At the ZBA meeting of 3/21 focusing on traffic impacts of the Sudbury Station application, many specific issues and concerns were raised which I will summarize below. In addition, there were serious process issues raised that call into question whether this application can be vetted effectively.

Figure 1: 3D computer model showing accurate slope based on GIS data and approximate location of buildings

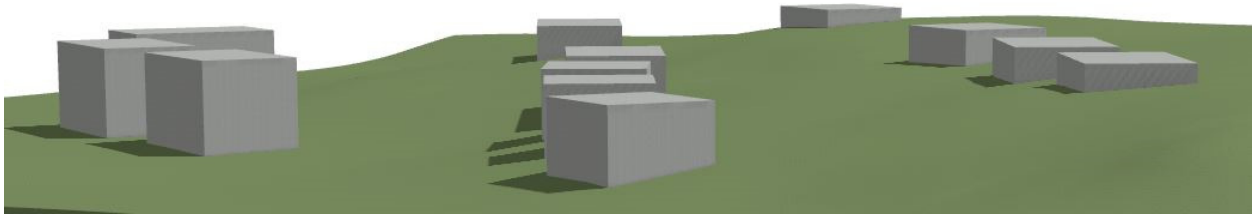
Since the developer has not provided any grading or section information, I have made rough calculations based on the plans and sections submitted. According to GIS maps, the top of the building area where the clubhouse is located is approx. elev. 250'. Drawing a line parallel to Hudson Rd. towards the RR track is a distance of approx. 700' and descends to approx. 185' at the trackbed, for a difference of 65' creating a slope of approx. 6 degrees. As the access road progresses uphill from Hudson road, the slope becomes steeper. The drawings indicate that most parking will be below grade, at least on the uphill side. Given an average building footprint of 13,000', and an average excavation per building of 5' (half underground), a total of 65,000 cubic feet per building, or 715,000 feet for 11 buildings, will have to be removed. This does not include additional excavation for footings and foundation walls. There is approx. 4500 linear feet of roadway at 20' wide (including sidewalks or shoulders), equaling 90,000 square feet x at least 3' deep to compensate for the slope and provide a level roadway, equaling 270,000 cubic ft. If we add the building and roadway area we have 985,000 cubic feet, or 36,481 cubic yards of material to be removed.

Note, I have not figured any removal of material for regrading of the site other than the area directly under buildings and roadways. Typically, projects on slopes are constructed with the cut and fill method, where material is removed from the high side and added to the low side. However, this assumes that either a) there is enough room to create a gradual slope on either side of the "plateau" (not possible on this narrow lot), or b) there are retaining structures on both the high and low sides (which are not indicated on the plans). Therefore, we must assume that this material is be removed from the site. (note, this does not include the considerable earth removal related to the stormwater detention basin). The largest overroad dump truck carries 14 yards of earth. If we divide 36,481/14, we have 2,605 truckloads of material removed from the site. Since each truck must make a return trip empty, we are facing a minimum of 5,211 dump truck trips during construction. This does not include the many trips incoming to the site to deliver gravel, concrete, and building materials. Some of these trucks will not be able to make the turn into the site as currently shown. When the Big Dig was underway, the "haul road" was built specifically to keep large trucks off of normally travelled roads to avoid creating traffic jams, accidents, and destroying the roadway and infrastructure. Clearly, this is not an option here.

The health and safety issues under review by the ZBA include issues related to construction. I strongly urge the board to request information from the developer regarding the earth removal issues raised herein, at this time, before any more peer review of incomplete traffic and safety data is undertaken. Since large trucks pose far more safety issues than cars, we must have a detailed understanding of the safety impact of thousands of trucks on our congested and narrow roads. Answers that do not include accurate topo sections based on stamped engineering drawings should be rejected. If the developer is unable to provide the necessary information at the proper level of detail, the process should be halted until such information can be provided.
